December 22, 2003

TO: Mr. Tim Johnson
American Telecommunications Certification Body Inc.
6731 Whittier Ave, McLean, VA 22101

RE: Airespace FCC ID: QTZAM1200ABG

2. 4 GHz block diagram

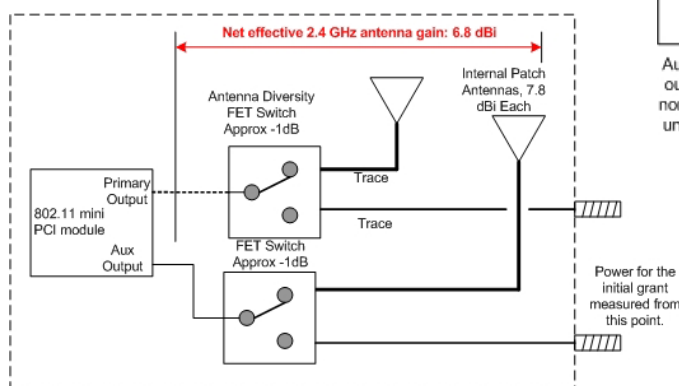
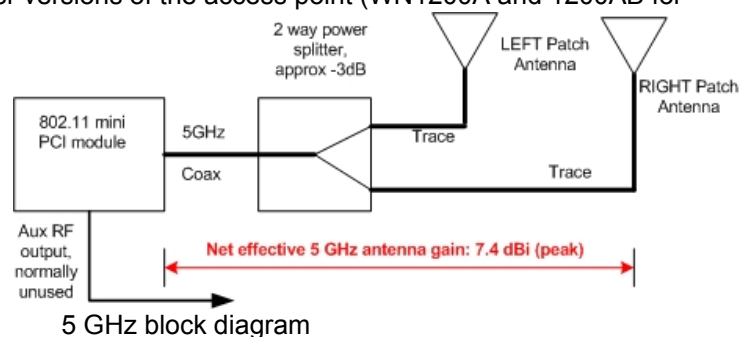
ATCB 14) The power measurement diagram does show the splitter and takes this into consideration in the calculations. However, the diagram does not appear to show the switch for the 5 GHz path. It is therefore uncertain if this was factored in as shown in the 2.4 GHz data. Please explain.

Airespace: The RF switch that existed in previous older versions of the access point (WN1200A and 1200AB for example) has been removed. There is still a FET switch on the 2.4 GHz "side" of the access point to select between internal and external antennas. The block diagrams shown in the reports are correct.
